COMMISSION DECISION

of 23 January 2009

amending Decisions 2006/861/EC and 2006/920/EC concerning technical specifications of interoperability relating to subsystems of the trans-European conventional rail system

(2009/107/EC)

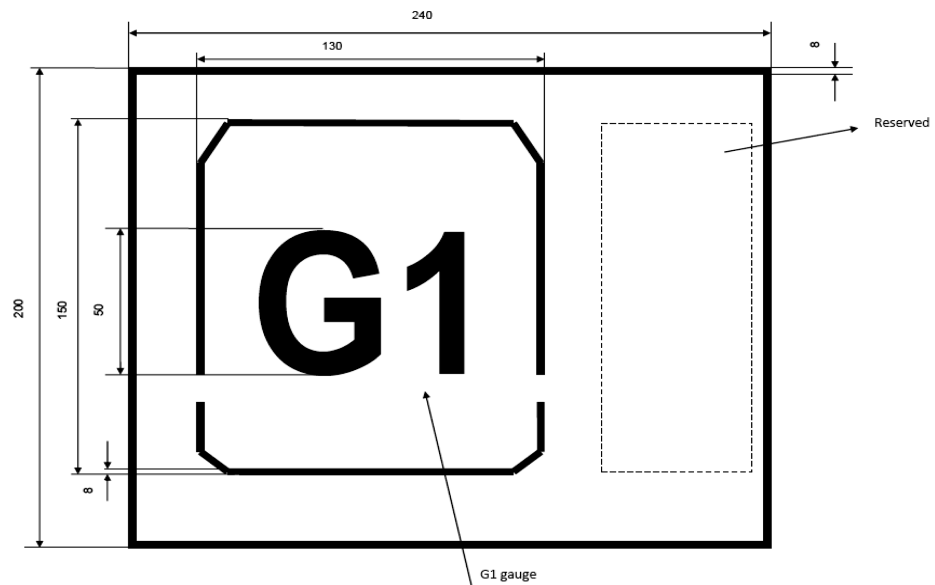
(a) in point B.3, remark 4) is replaced by the following:

'4) Existing wagons that can be forwarded with the same loads as in S-traffic at 120 km/h, are already marked with the sign "****" placed to the right of the maximum load markings; no additional wagons can be added to this category.'

(b) in point B.3, the following remark is added:

'5) New wagons with the braking performance of "S2"-wagons according to the table in section 4.2.4.1.2.2, that can be forwarded with the same loads as in S-traffic at 120 km/h according to particular specifications listed in Annex Y, shall have the sign "****" placed to the right of the maximum load markings.'

'B.32. MARKING OF WAGONS GAUGE

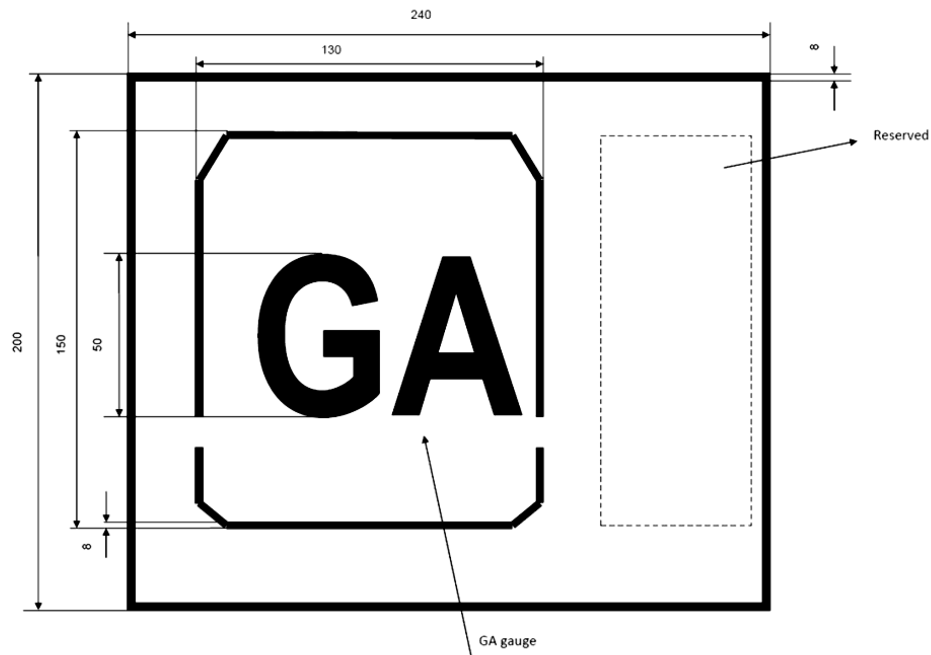
(c) point B.32 is replaced by the following:

(1) Wagons built to gauge G1 will be marked as follows:

2.2. Strength of main vehicle structure

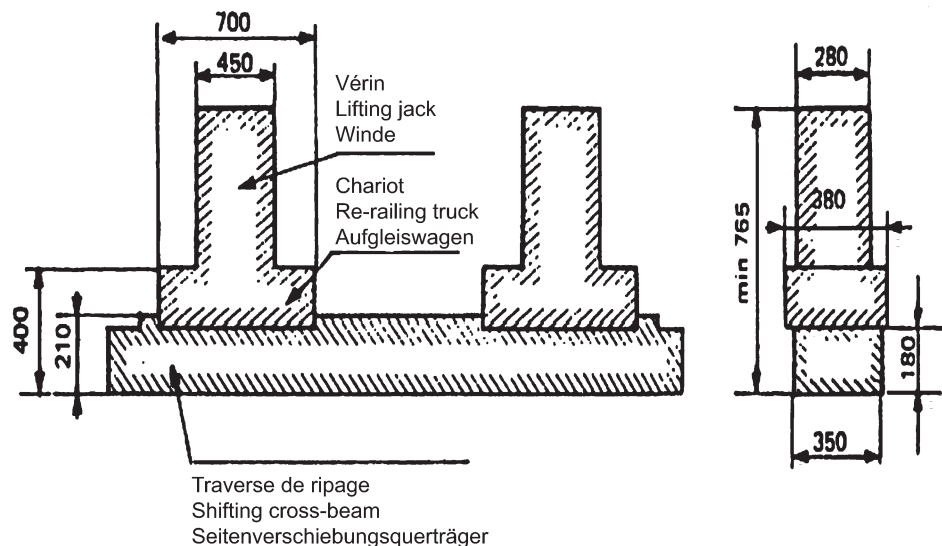
In addition to the specifications of section 4.2.2.3.1 of this TSI, it is also required that:

- only tests and calculations for which numerical simulations have been validated are accepted;
- the maintenance file should take into account the following: the use of thermomechanical rolled steel requires special measures regarding heat (treatment).

Figure 1

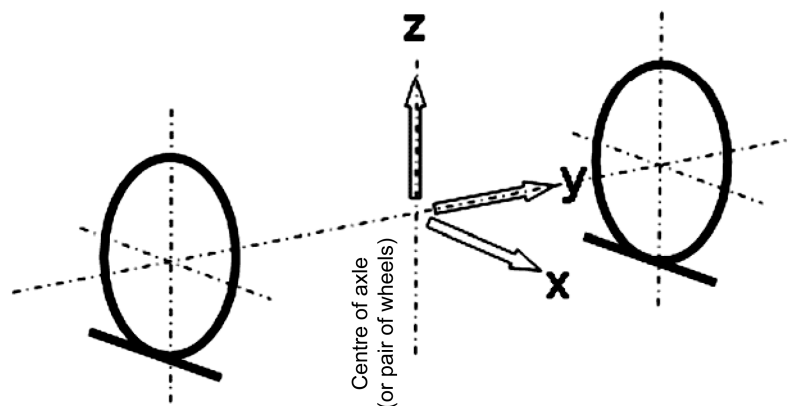
Rolling stock coordinates: rolling stock coordinates, figure 1, are based on the right hand rule Cartesian coordinate system, where the positive X-axis (longitudinal) is along the vehicle in the direction of travel, the Z-axis is vertically upwards and the origin is at the centre of the wheelset axle. The Y-axis is the lateral axis.

Figure 2

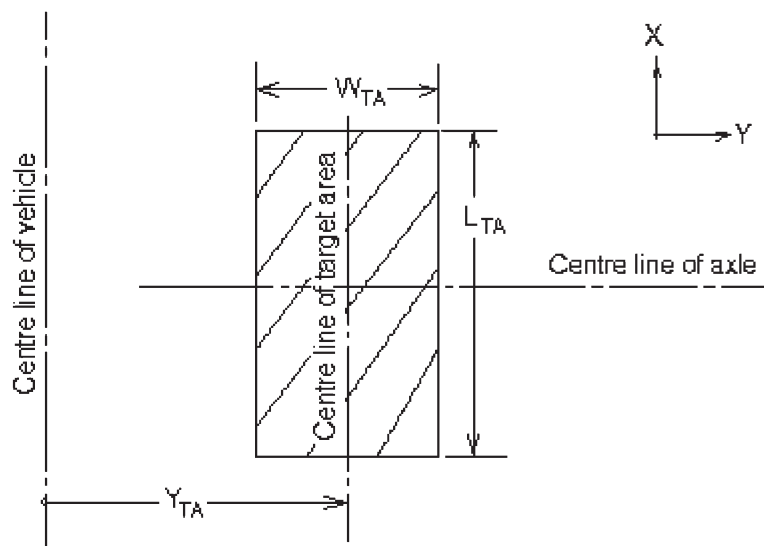
The target area is set in space relative to the axle dimensions, and defines an area in which a HABD can focus to monitor the temperature of an axle box. Figure 2 shows the position and minimum dimensions of the target area using rolling stock coordinates.

Taking into account mechanical tolerances the target area shall:

- have a lateral width, WTA, greater than or equal to 50 mm;
- have a longitudinal length, LTA, greater than or equal to 100 mm.

In the XY plane the centre of the target area shall be positioned at a lateral distance, YTA, relative to the centre of the axle (or centre of a pair of wheels at the same position), where 1 065 mm is less than or equal to YTA and YTA is less than or equal to 1 095 mm. In the longitudinal axis the centre of the target area shall be congruent with the centre line of the axle.

Figure 3

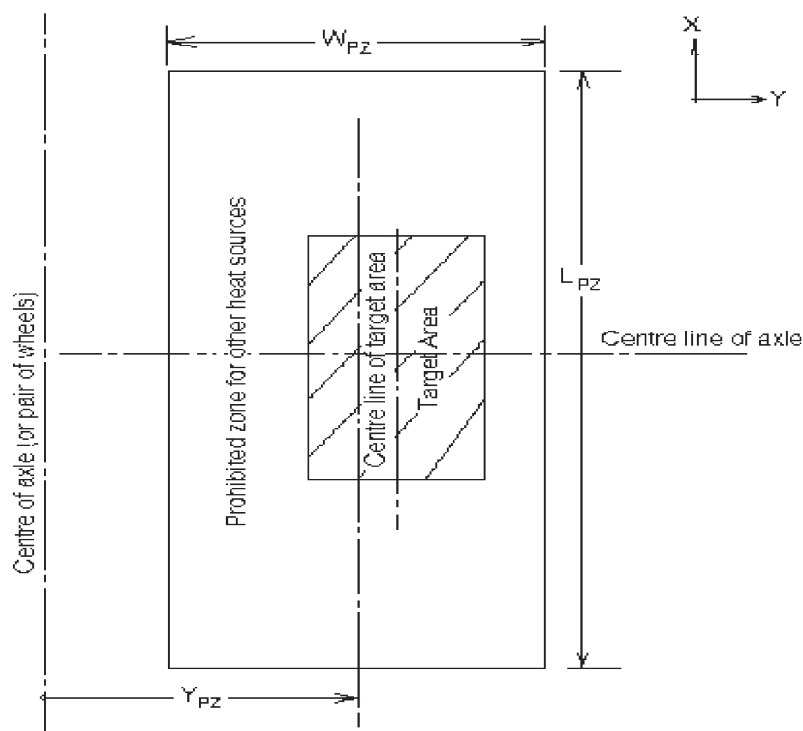
The prohibited zone is defined by a rectangular area, which includes the target area, and is extended vertically to form a virtual cuboid. The dimensions of the cuboid are LPZ and WPZ in the XY plane and HPZ in the vertical axes. Figure 3 shows a possible position of the target area in the prohibitive zone using rolling stock coordinates.

The dimensions of the prohibitive zone's cuboid, taking into account mechanical tolerances, shall be:

- lateral width, WPZ, greater than or equal to 100 mm;
- longitudinal length, LPZ, greater than or equal to 500 mm;
- vertical height, HPZ, starts at a point in the XY plane immediately above the HABD and ends at either the height of the target area, the height of a thermal shield or the height of the vehicle.

- in the lateral direction, YPZ = 1080 mm \pm 5 mm measured relative to the centre of the axle (or centre of a pair of wheels at the same position);
- in the longitudinal direction it shall be congruent with the centre line of the axle \pm 5 mm.
